Australian Mobile
Telecommunications
Association

Submission to the Australian
Communications & Media Authority

Response to consultation on Review of the 850 MHz and 1800 MHz spectrum licence technical frameworks

Figure 1—comparison of potential emission limits for AAS transmitters.

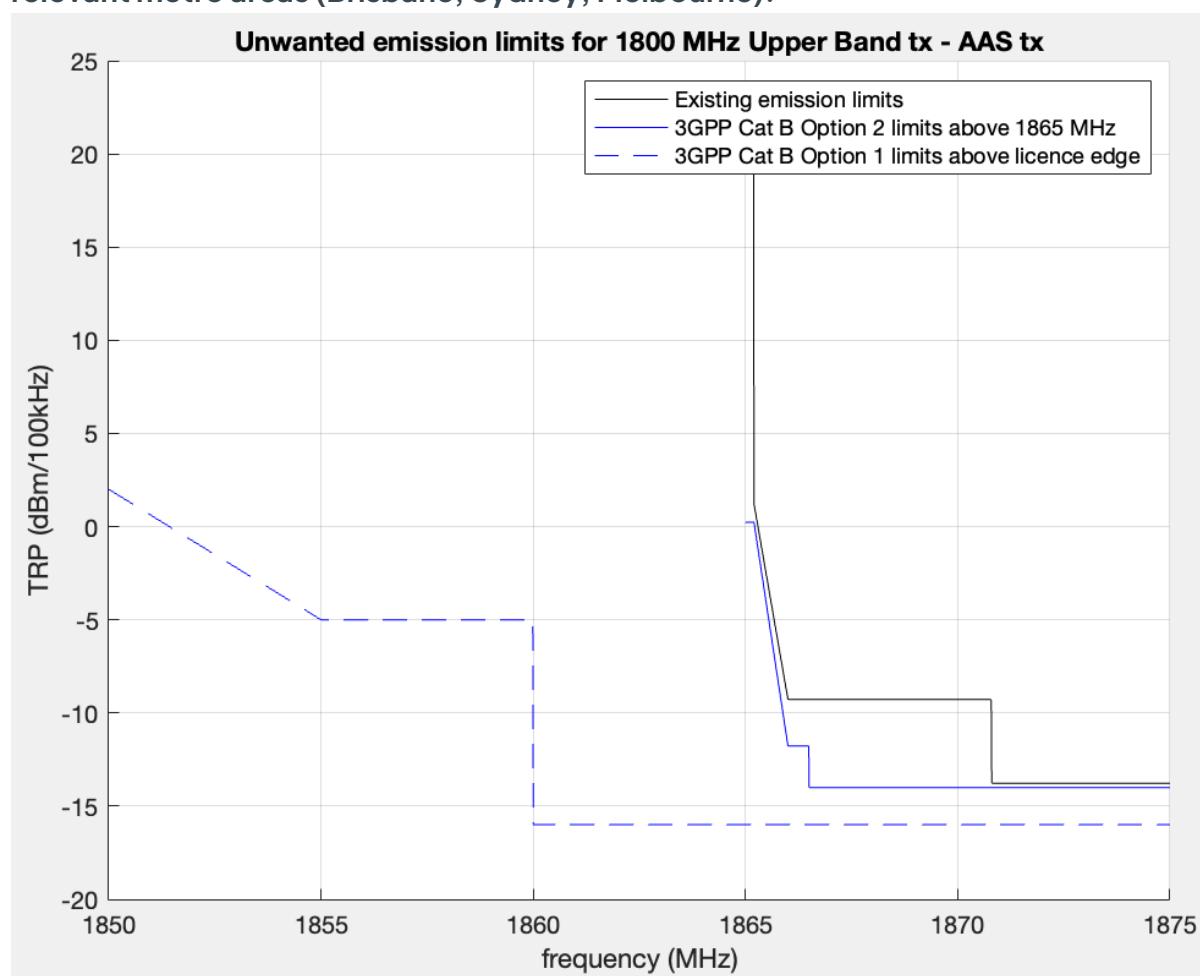
For AAS transmitters, Figure 1 below shows a comparison of the A-limits for a spectrum licence whose licensed bandwidth is completely below 1850 MHz, along with the B-limits applicable above 1865 MHz. It shows that the existing emission limits are actually higher than the alternative CBO2 limits, so we are happy for the **existing emission limits in Core condition #7 of the 1800 MHz band spectrum licences to be adopted for the B-limits for AAS transmitters, except that the frequency offset is relative to a fixed upper band edge**. The fixed upper band edge is 1865 MHz in the relevant metro areas (Brisbane, Sydney, Melbourne).

Figure 2—comparison of potential emission limits for Non-AAS transmitters, (a) when 22.5 dBi antenna system gain is assumed and (b) when 15 dBi antenna system gain is assumed.

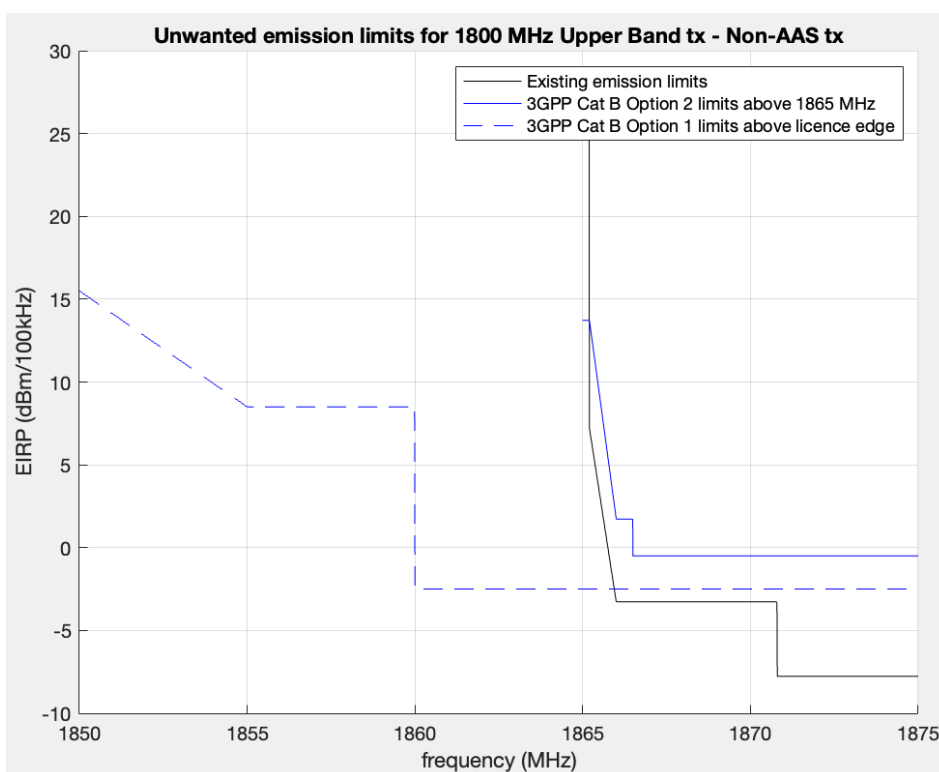
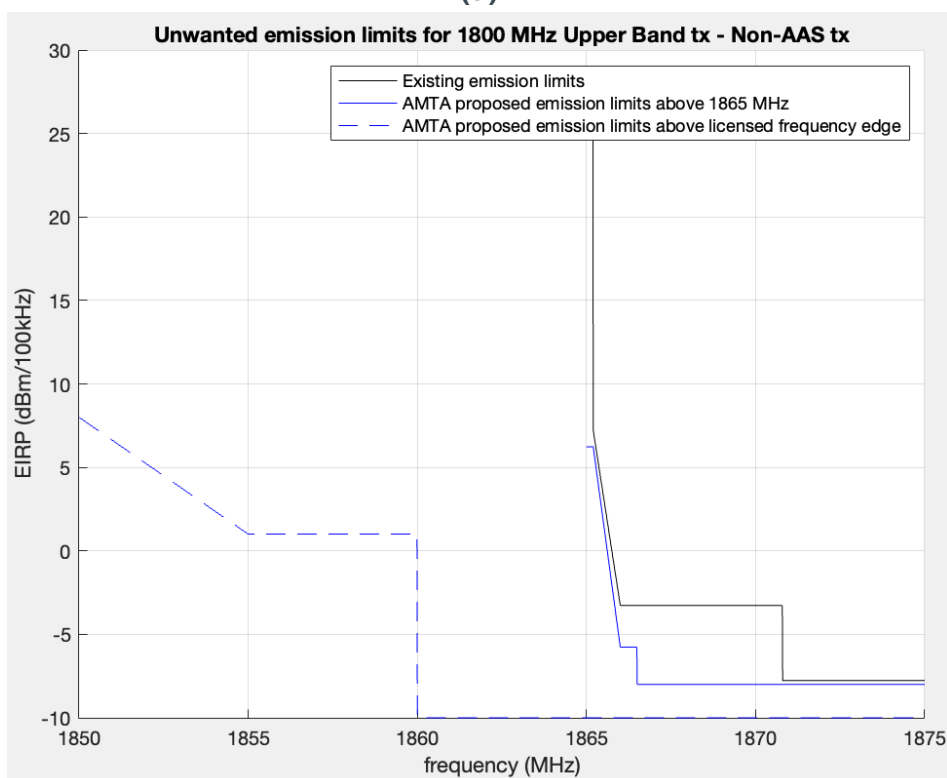
For Non-AAS transmitters, Figure 2 below shows a comparison of the A-limits for a spectrum licence whose licensed bandwidth is completely below 1850 MHz, along with the B-limits applicable above 1865 MHz. It shows that the alternative CBO2 limits are actually lower than the existing emission limits when antenna system gain is ≤ 15 dBi. We recognise that where the antenna system gain increases above this, the alternative CBO2 limits start to creep above the existing limits.

Within the first 5 MHz, and excluding the lowest 200 kHz (so the 4.8 MHz between 0.2 and 5.0 MHz offset), the existing EIRP limits are 17.3 dB higher than the CBO2 conducted limits. This means that the CBO2 conducted limits could be used with a system gain of up to 17.3 dB and would still be within the existing EIRP limits, while higher system gain values of X dB would be exceeding the existing EIRP limits by up to $(X-17.3)$ dB, i.e. up to 5.2 dB exceedance for system gain up to 22.5 dB.
